Fifth Gen Cascadia Turn Signal/DRL - Update

Affected Models:
5th Generation Cascadia

Headlamp assembly image showing new p/n

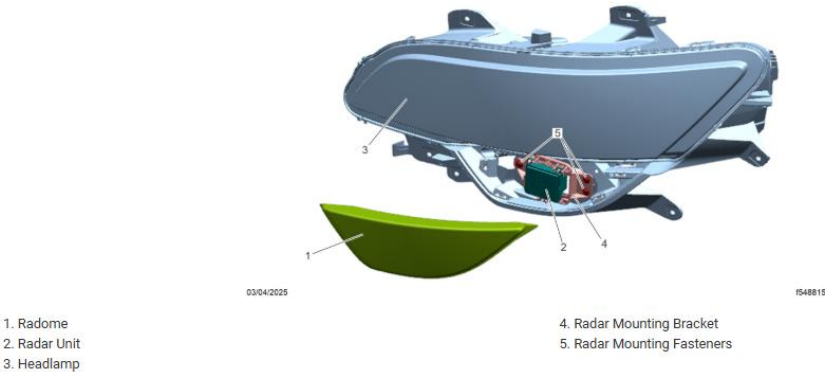
Root Cause: Solder delamination on PCB due to thermal fatigue

Status Update:
Solder improvement created a part number change from A66-20649-008/009 to 010/011 (blue)
New higher efficiency LED was implemented to use less current – June 2026

Correction: Fix as failed; the failed headlamp only. Replace the headlamp assembly.
